ADDENDUM NO.03 DATE: 11/03/21

PROJECT:
'Matilda Torres High School, Toros Stadium'
Matilda Torres High School
16645 Road 26. Madera, CA 93638

The following additions, deletions, and revisions to the SHEETS and Project Manual are hereby made and do become a part of these Contract Documents.

AD3-MX01

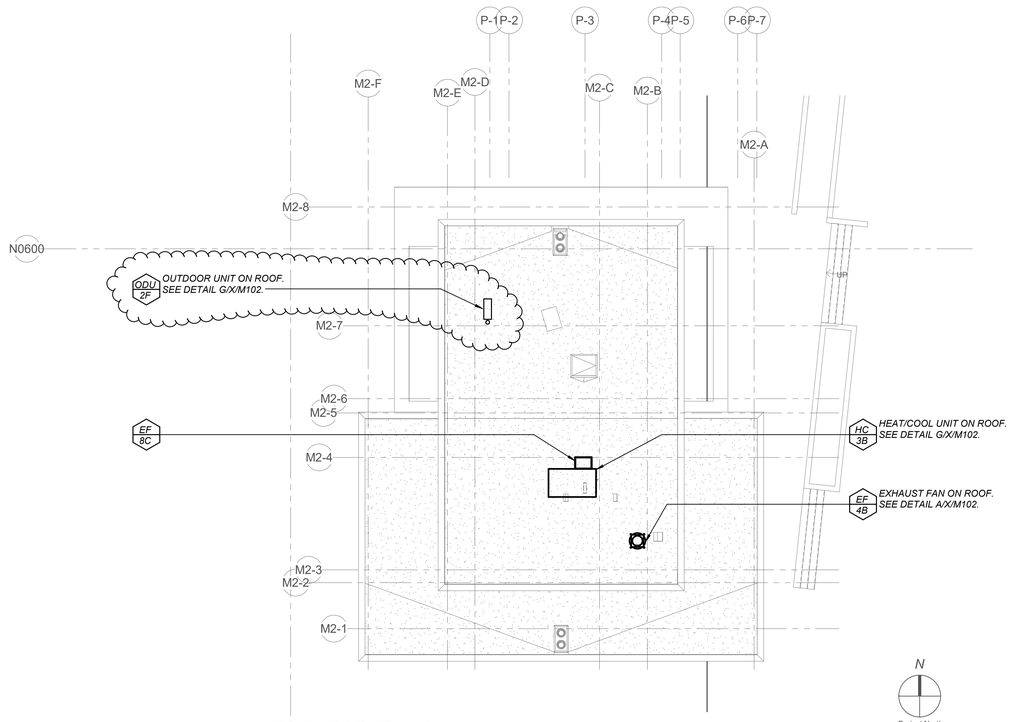
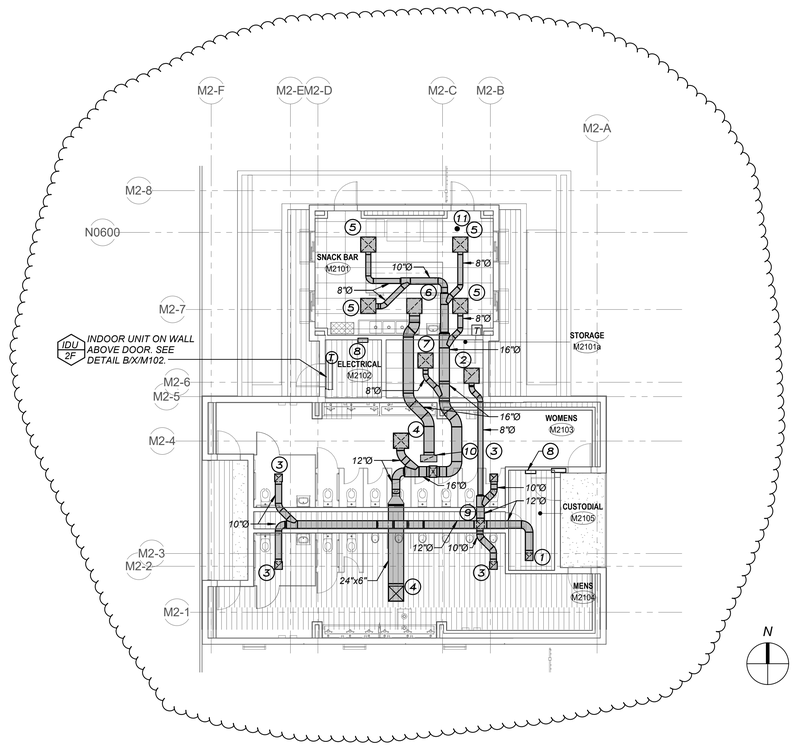
AD3-M02 Refer to Drawings, Sheet M/M102:

1. Replace sheet with attached drawing AD3-MX01 .

a. Added IDU-2F to Electrical room, added ODU-2F to roof plan.
